Airworthiness Information Leaflet

Jabiru SK, SP, UL & UL430/450

Main Undercarriage Bolts Inspection/Replacement/Mandatory Life

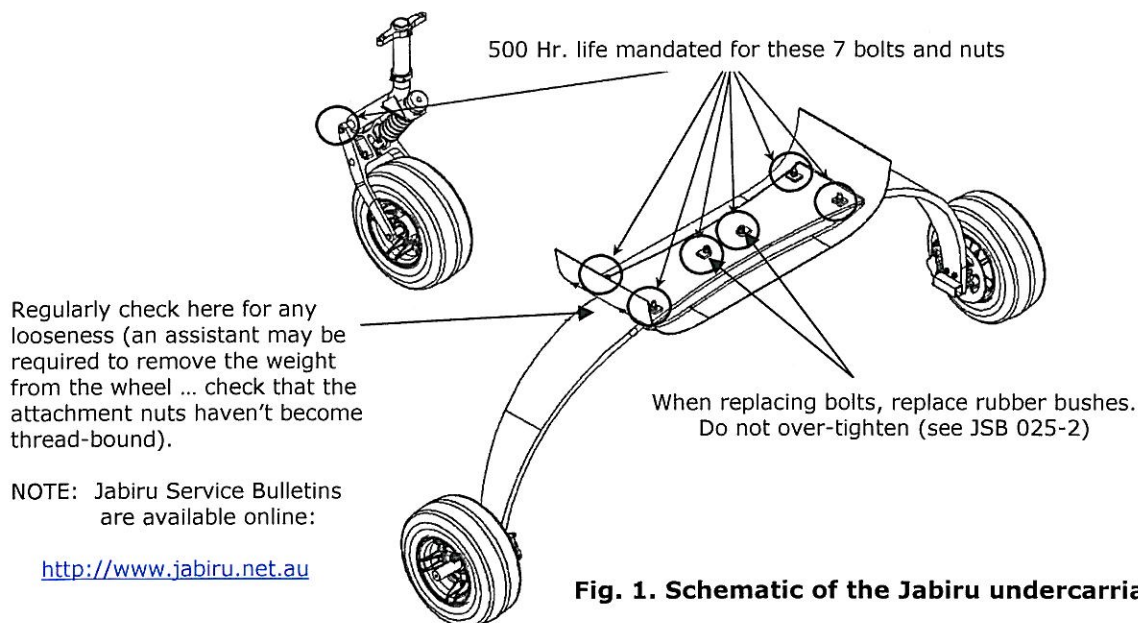
- a. **Bolt Size** – Establish the bolt's diameter; should the bolt be a 5/16" (AN5) bolt then this will need to be changed in accordance with instructions given in JSB 008-1 (31st March 2005).
- b. **Bolt Grip length** - Ensure that the nut hasn't 'bottomed-out' on the thread, washers may be used as necessary to ensure positive grip.
- c. **Fore/aft movement in the leg** – After removing the weight from the wheel there must be no relative movement between the leg and the attaching clamp, if movement is detected the attachment must be disassembled so that the leg and clamp can be fully inspected. Should a leg be found loose it is required that the attaching bolts be replaced with new bolts on re-assembly (see compliance requirements Part 2. 3. overleaf).
